West Burton Solar Project

Environmental Statement Appendix 8.4: Consultation

PINS reference EN010132
Document reference: WB6.3.8.4

As shown on mark up Figure 7.12 West Burton 1 Augmented ZTV

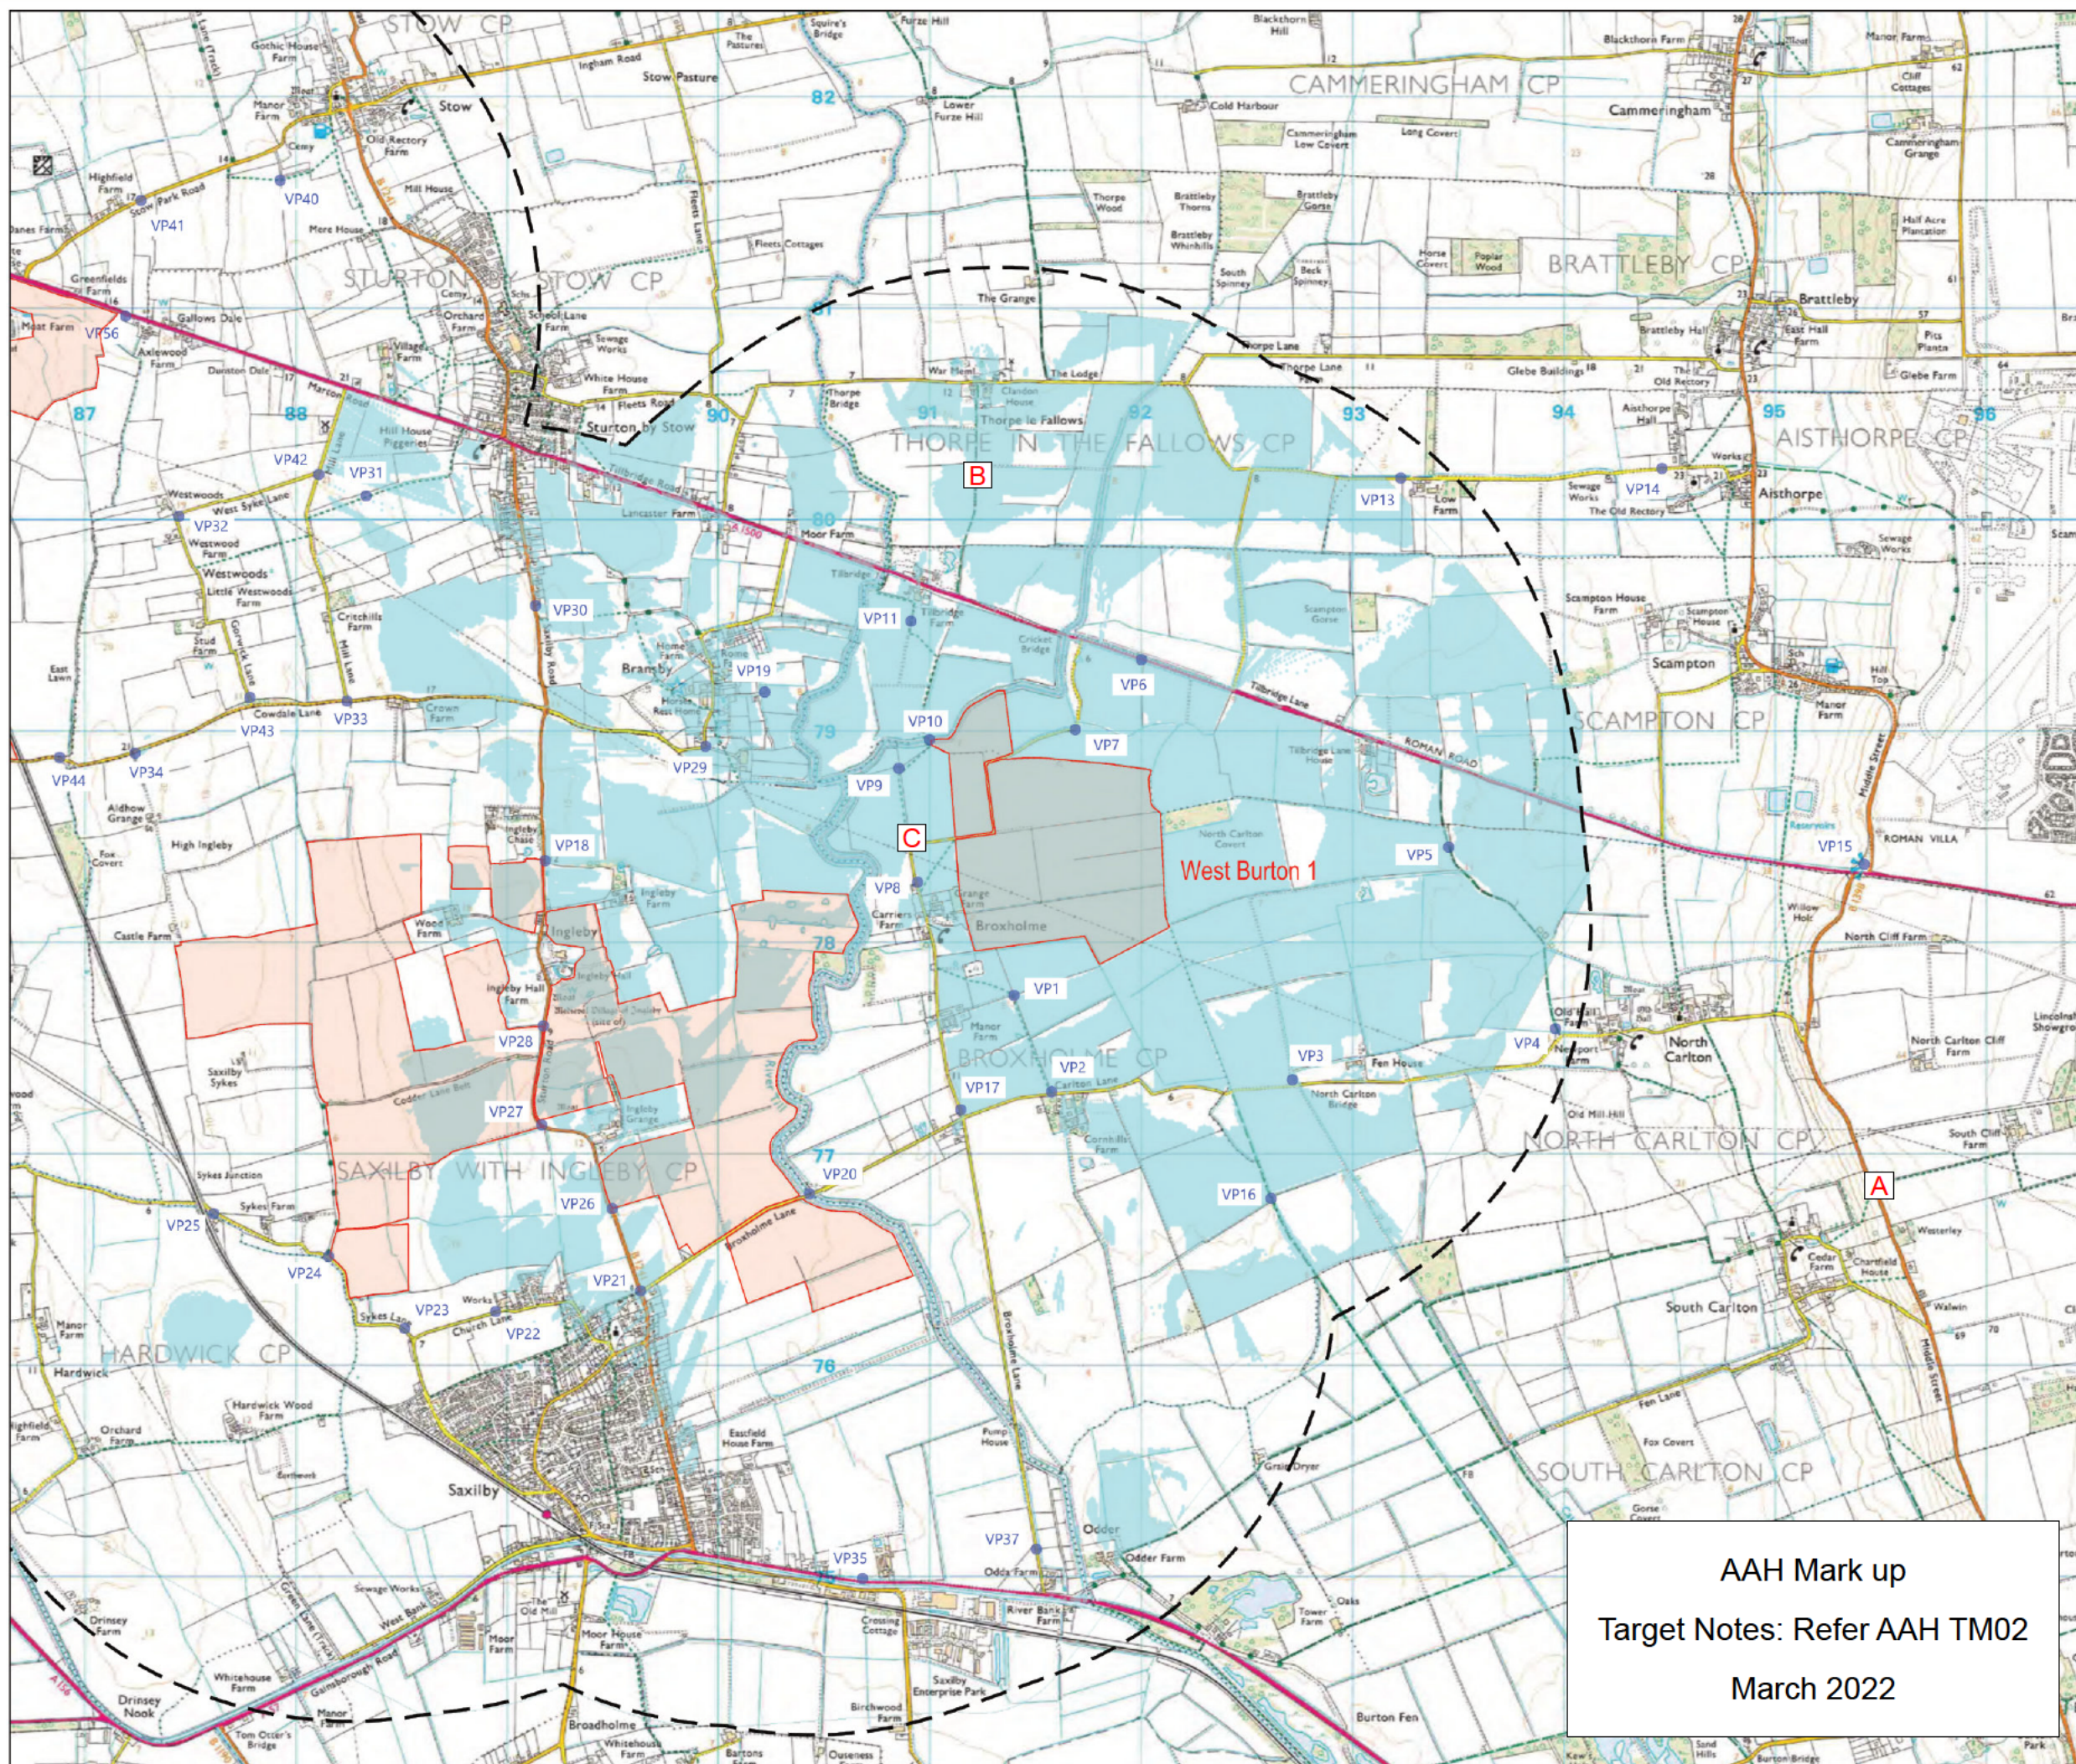
- N. **Additional viewpoint should be included from Torksey Viaduct looking north east.** While existing intermittent vegetation will likely screen views from this heritage asset, due to the elevated nature of this feature, receptors may have views of West Burton 3 looking to the north east. Photography should provide the most advantageous views of the site and proposed development; and

- O. **Additional viewpoints should be included from along Cowdale Lane along the southern boundary of West Burton 3 looking north.** While VP44 and VP45 are in close proximity, there are two locations that offer clear open views across West Burton 3: at the Stow Park farm access; and close to the railway line as the road rises in elevation which offers more elevated views. These views may also include taller proposed elements of the Gate Burton solar development, subject to the final design proposals. Photography should provide the most advantageous views of the site and proposed development.

Figure 7.13
West Burton 2
Augmented ZTV

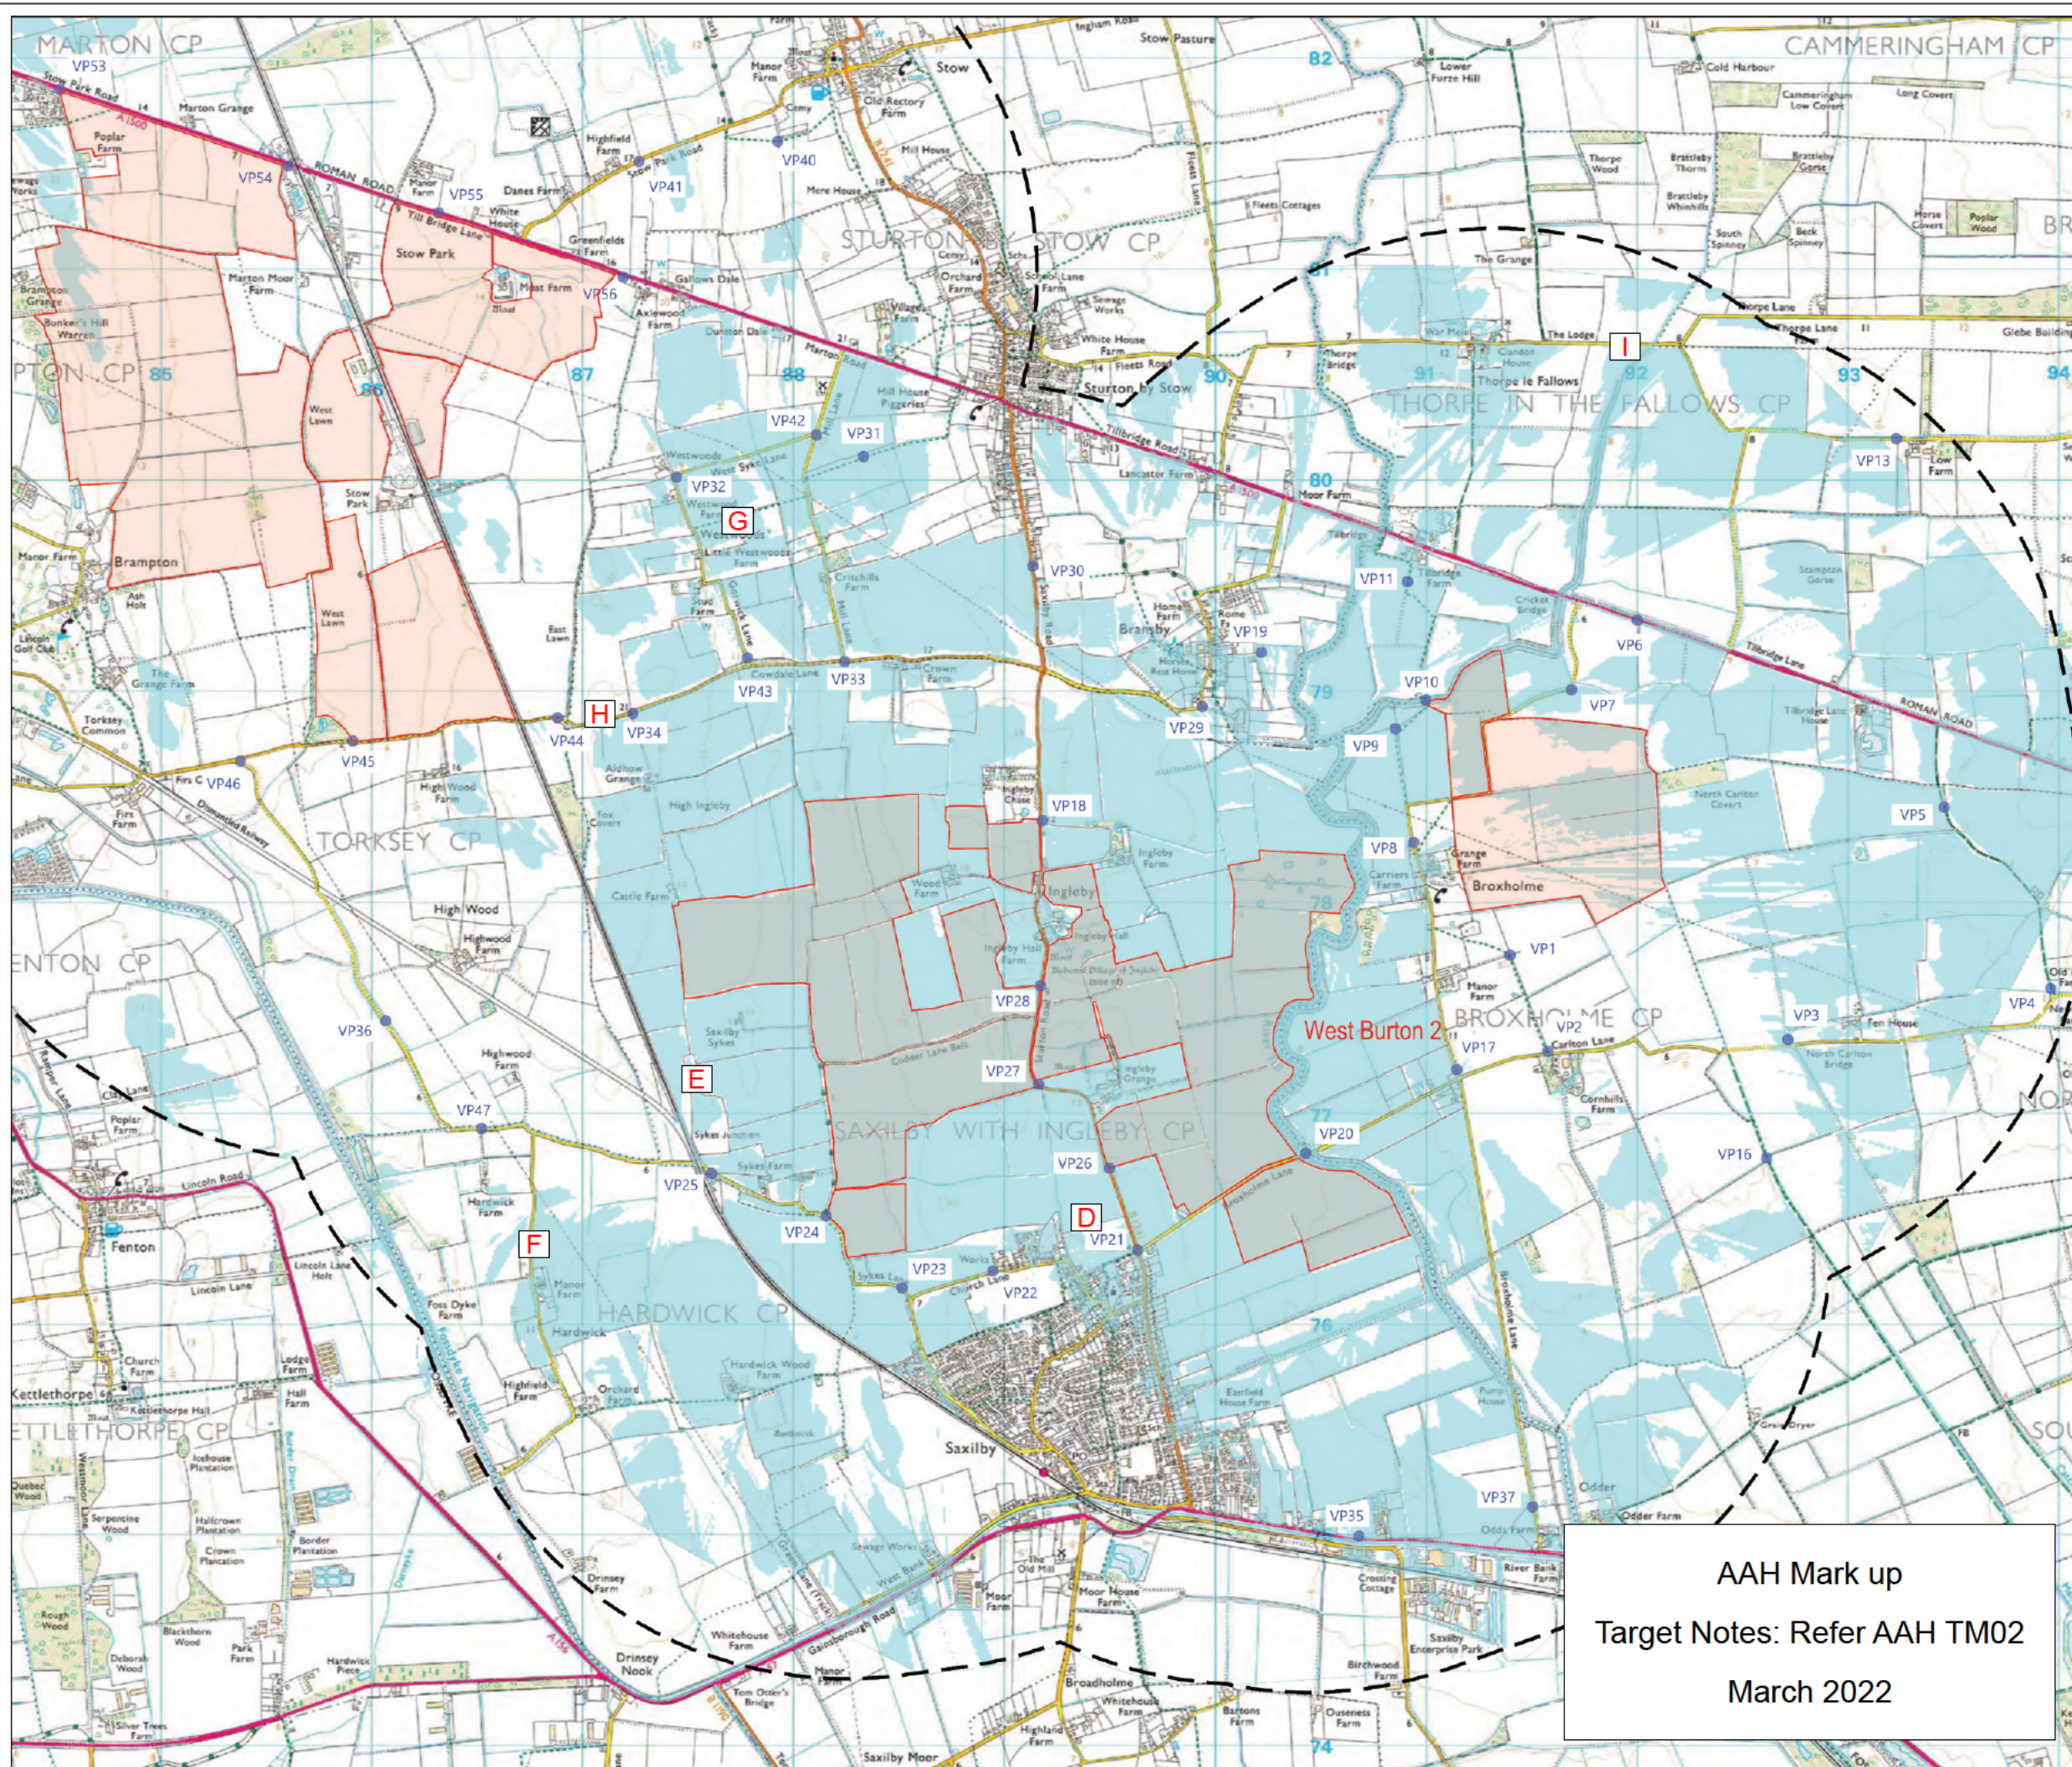
As shown on mark up Figure 7.13 West Burton 2 Augmented ZTV

Figure 7.14
West Burton 3
Augmented ZTV

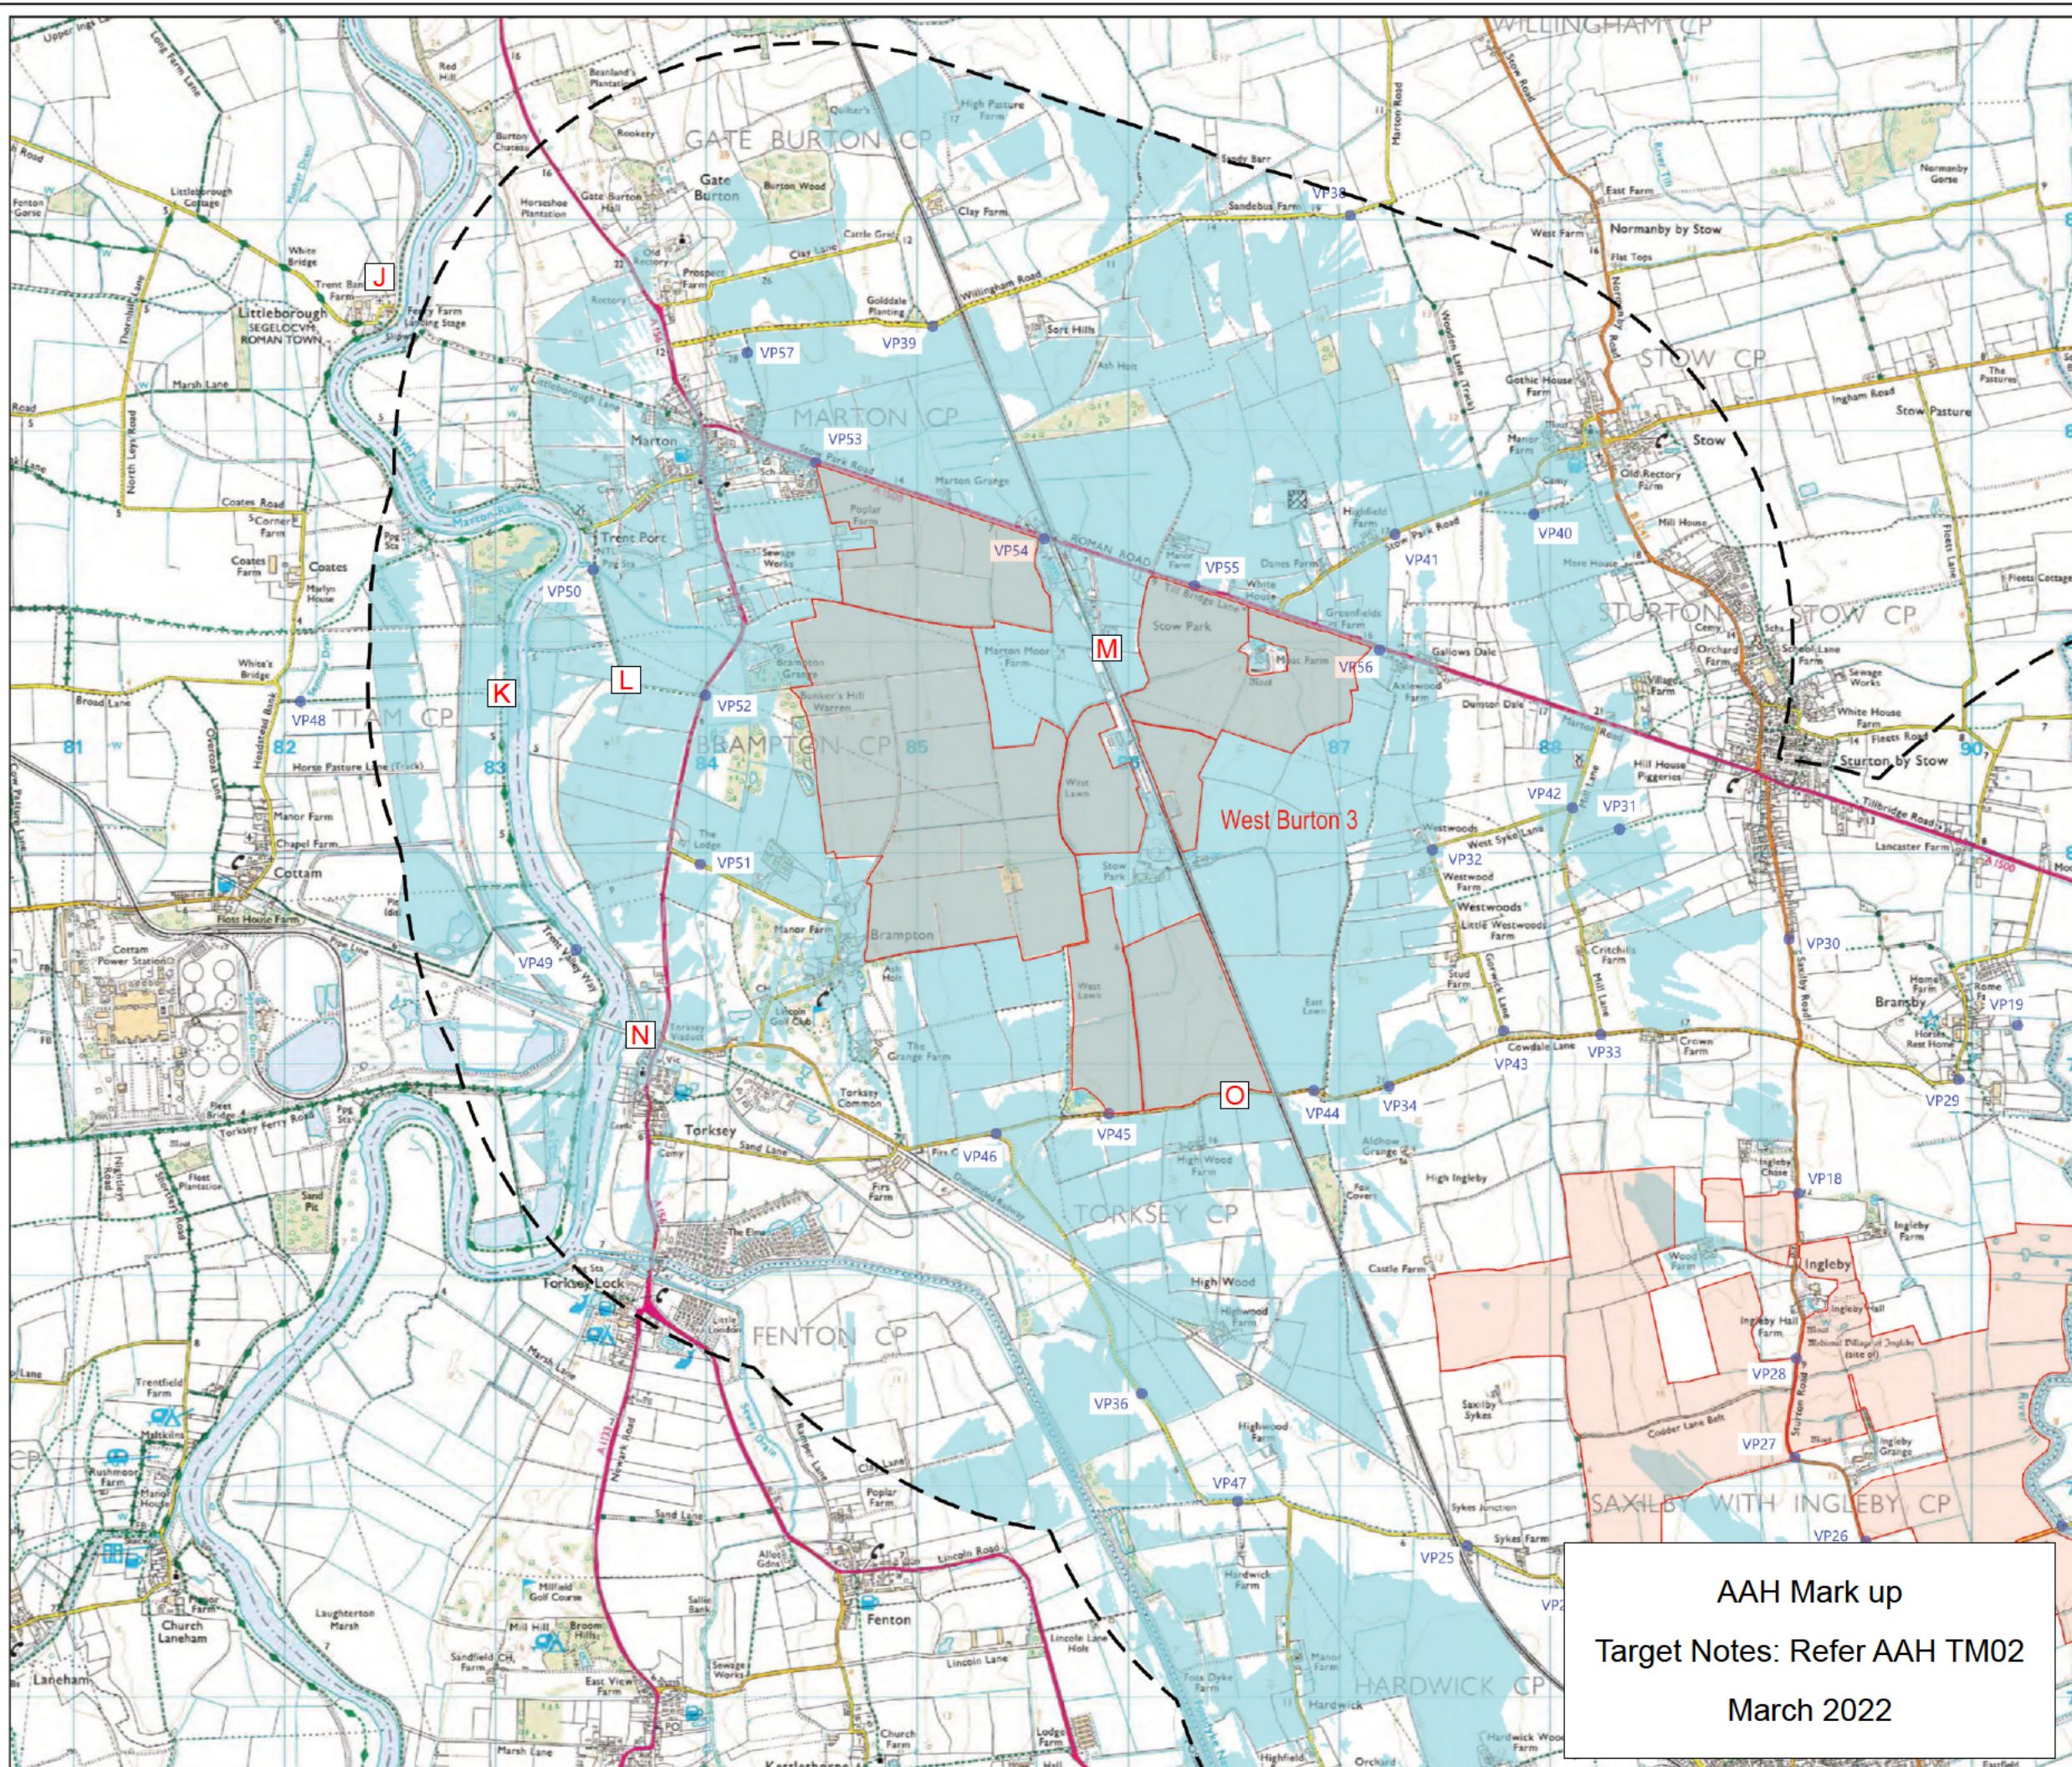
As shown on mark up Figure 7.14 West Burton 3 Augmented ZTV
